Access Compliance Report

Public Rights-of-Way

(Curb Ramps)

Intersection ID: 30007	Main Street: DUNBERRY_CT	Cross Street: OAKBORO_LN	Location: NE
ADA ID: 3D1EEFEF866F	Ramp Type: PerpDiag	Initial Pass/Fail: Fail	Overall Compliance: No
Codes/Mitigation Info/Possible Solution		Field Measurements/Component Compliance	
Severity Score: 33.75

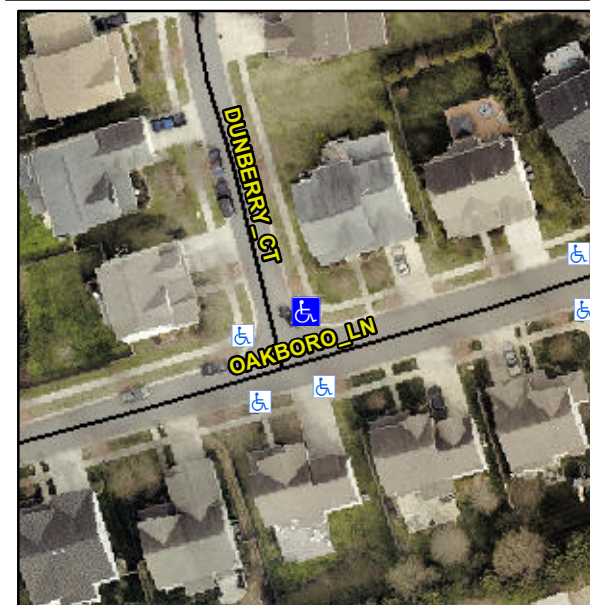
Not Found, R304.5.1, R304.5.3

Compliance	Description	Data	Compliance	Description	Data
N/A	Ramp Length (in)	69.5	Yes	Ramp Slope (%)	6.5
No	Ramp Width (in)	47.0	No	Ramp XSlope (%)	11.8
N/A	Flare Type LT	N/A	N/A	Flare Type RT	N/A
N/A	Flare Slope LT (%)	N/A	N/A	Flare Slope RT (%)	N/A
N/A	Flare Traversable LT?	N/A	N/A	Flare Traversable RT?	N/A
N/A	Landing Length (in)	N/A	N/A	DWS Provided?	N/A
N/A	Landing Width (in)	N/A	N/A	DWS Contrast?	N/A
N/A	Landing Slope (%)	N/A	N/A	DWS Length (in)	N/A
N/A	Landing X Slope (%)	N/A	N/A	DWS Full Width?	N/A
N/A	Landing Curb? (Y/N)	N/A	N/A	DWS Offset (in)	N/A
N/A	Shared Landing?	N/A			
N/A	Gutter Ponding?	N/A	N/A	Gutter Slope (%)	N/A
N/A	Gutter Lip Ht (in)	N/A	N/A	Gutter X Slope (%)	N/A
N/A	Painted X Walk1?	No	N/A	Painted X Walk2?	No
	X Walk 1 Direction	To W		X Walk 2 Direction	To S
N/A	X Walk 1 Width (in)	N/A	N/A	X Walk 2 Width (in)	N/A
	X Walk 1 Slope (%)	3.9		X Walk 2 Slope (%)	5.2
	X Walk 1 X Slope (%)	1.7		X Walk 2 X Slope (%)	8.9

Remove & Replace Curb Ramp With Two New Directional Ramps or Equivalent.
